Technical Service Bulletin

NUMBER: 19-02-00 Rev. A

GROUP: Steering

Ignition Lock Cylinder Service

FIGURE 1

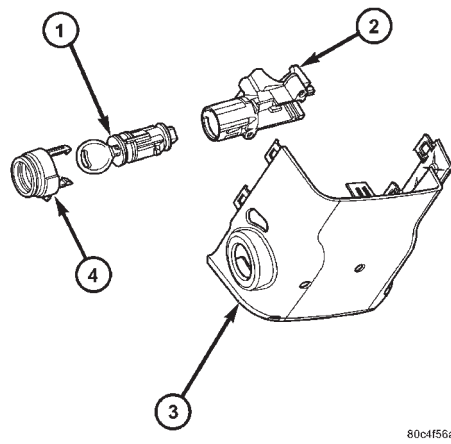
Recent changes to the ignition lock cylinder have resulted in the removal of a chamfer on the lock cylinder retaining pin. This may cause the pin to hang up on the plastic trim ring when the lock cylinder is removed. If this situation is encountered on any of the models listed above, it may be necessary to remove the trim ring prior to removing the lock cylinder. This is done by unseating the retaining tabs on the trim ring and removing it. The lock cylinder can then be removed without any interference (See Figure 1). Future models will modify the lock housing to eliminate this condition.
